Index 711-003 Interchange Markings

LAST REVISION 11/01/25	REVISION	DESCRIPTION:	FDOT FY 2026-27 STANDARD PLANS	INTERCHANGE MARKINGS	INDEX 711-003	SHEET 6 of 8
------------------------------	----------	--------------	--------------------------------------	----------------------	------------------	-----------------

TYPICAL INTERSECTION

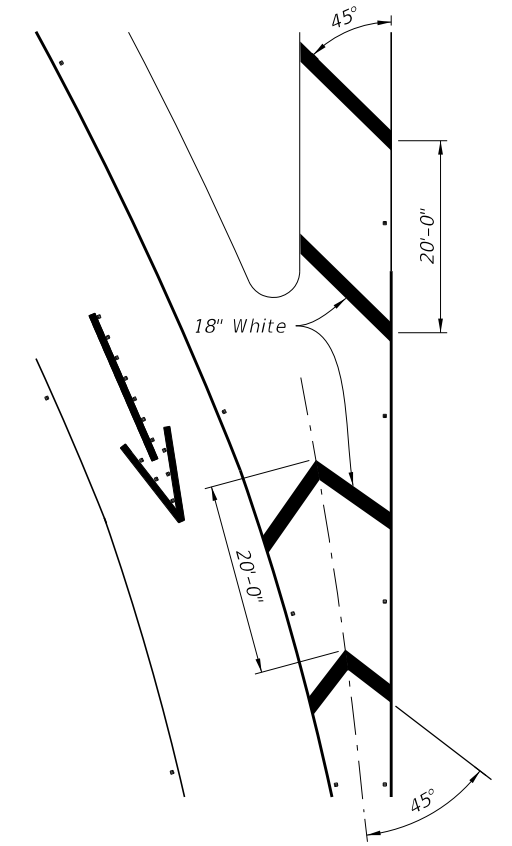
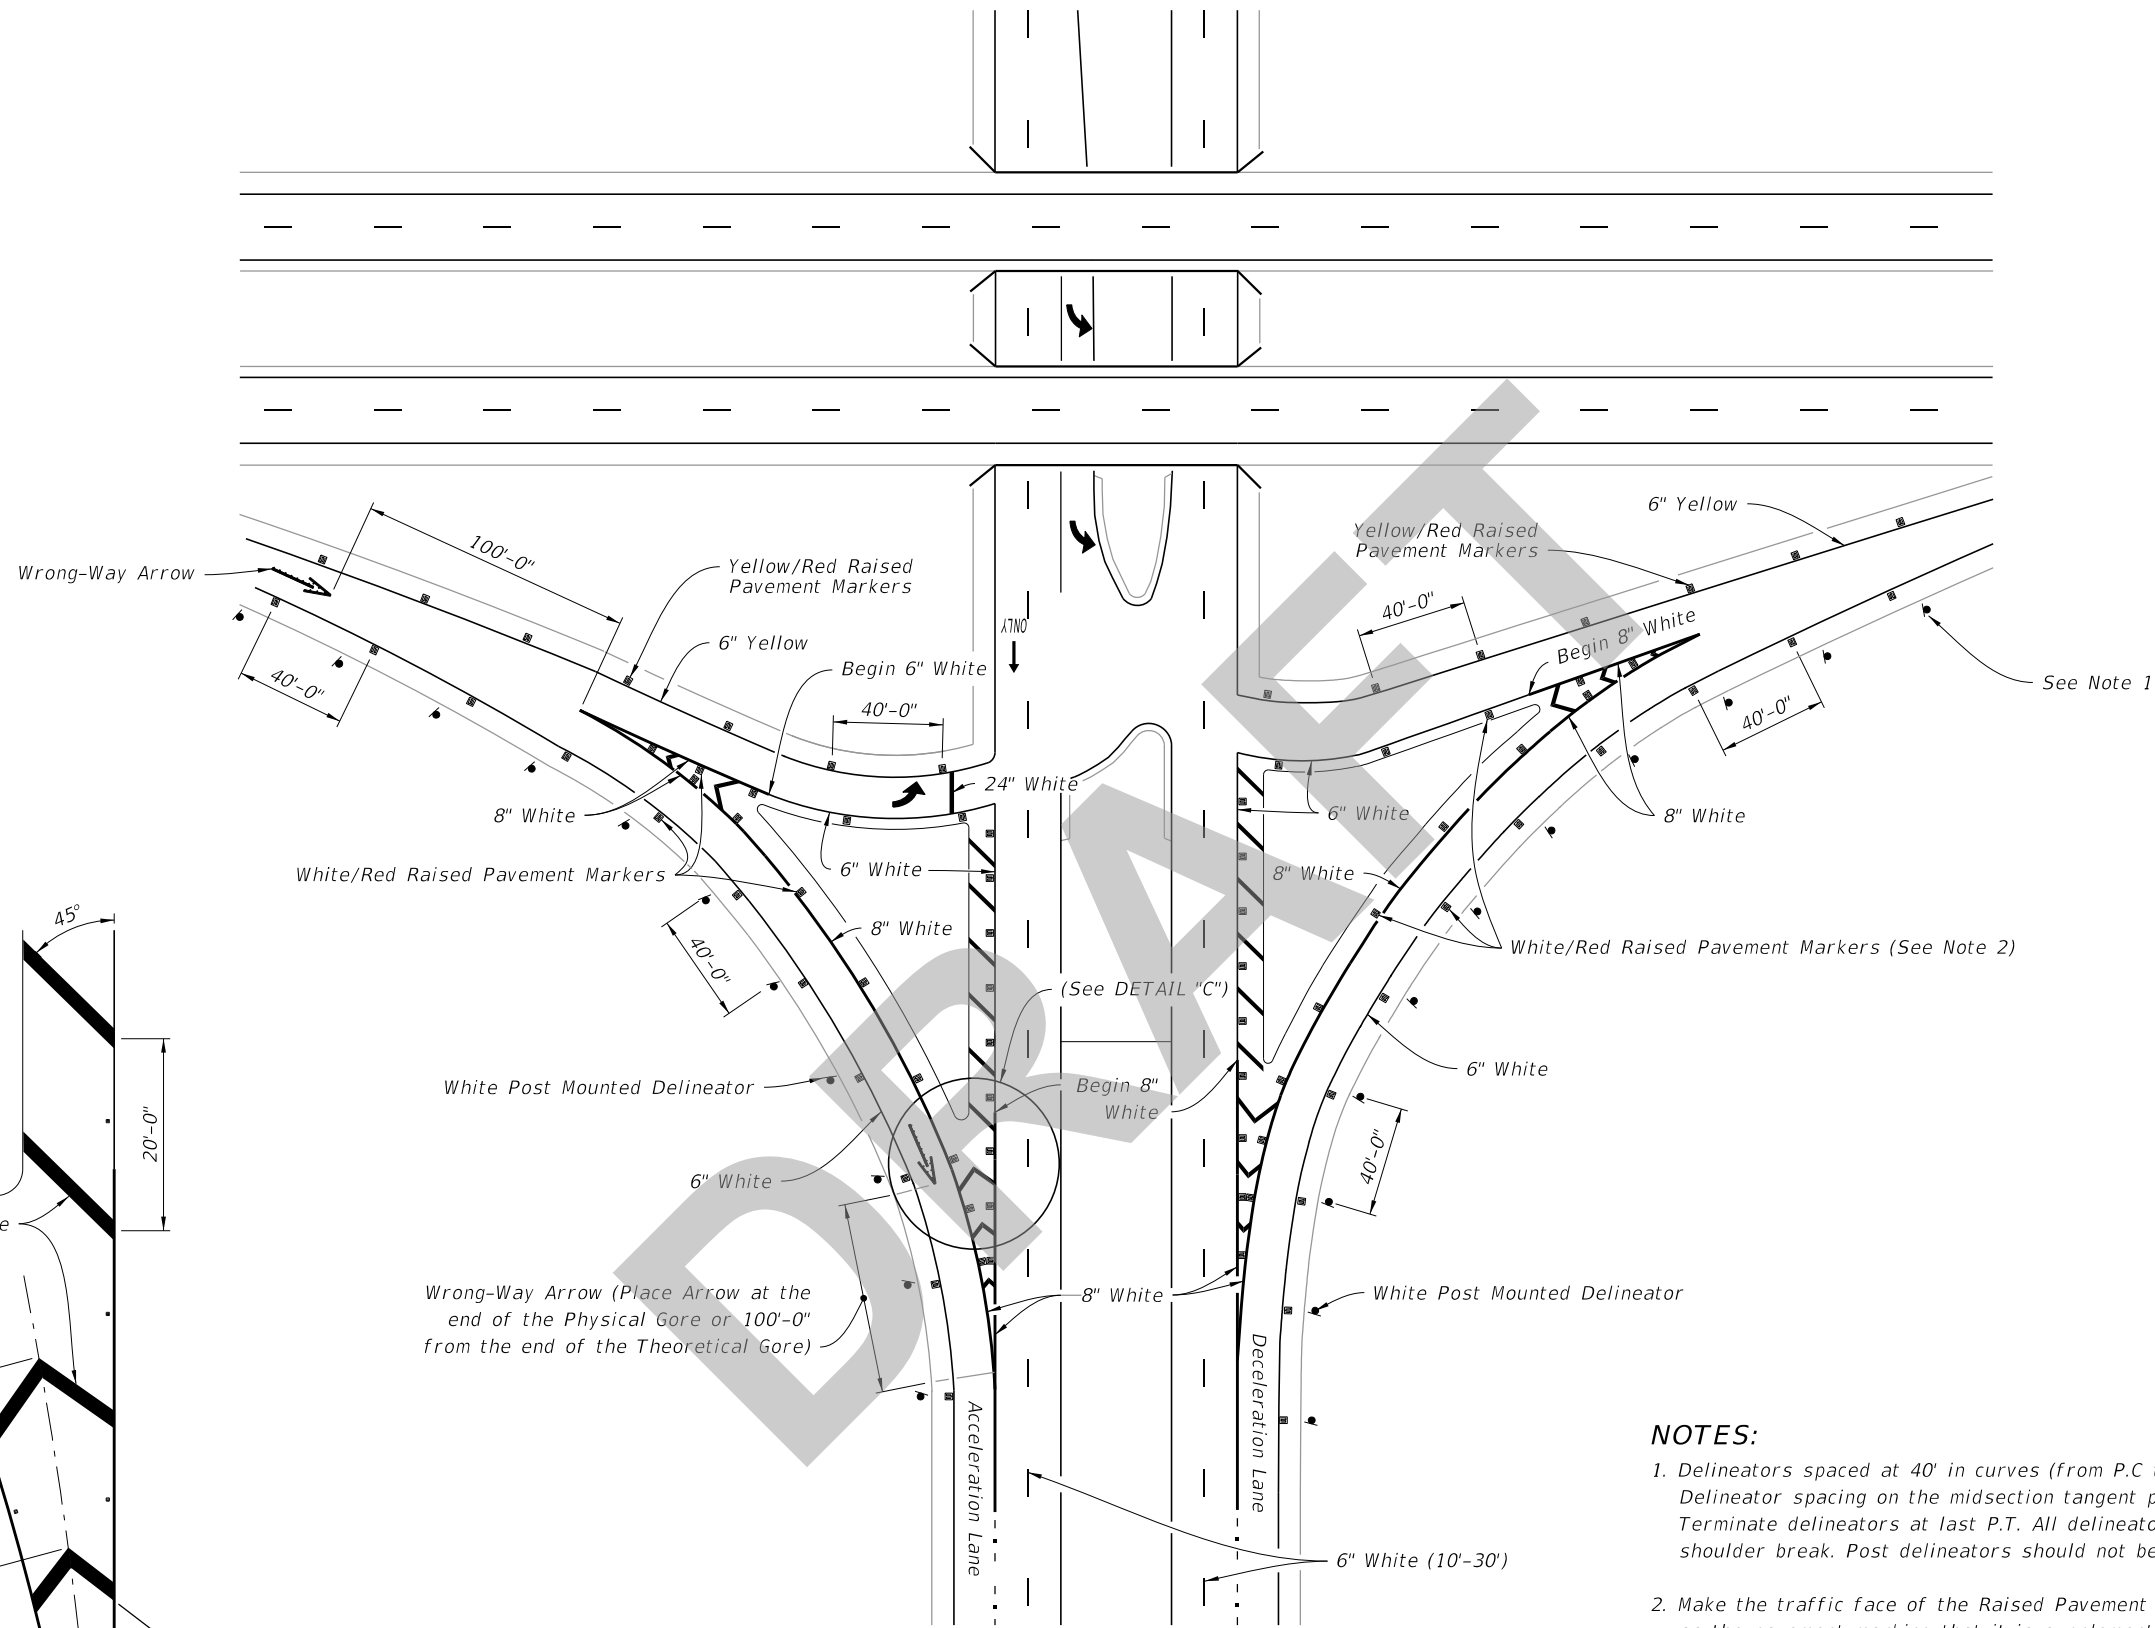
COMMENT: 1. On the top left side of the typical intersection, it would make more sense to indicate the 'Begin 6" White' rather than 'Begin 8" White', consistent with the traditional "left-to-right" direction or order.

2. The chevron pavement markings located in the middle of the typical intersection (adjacent to the 4 lanes divided roadway) should be labeled '18" White' markings.

3. Show the spacing dimensions for the roadside hatching/RPMs located in the middle of the typical intersection (adjacent to the 4 lanes divided roadway).

RESPONSE: Agreed to all three of these comments.

CHANGE MADE TO INDEX: Yes.
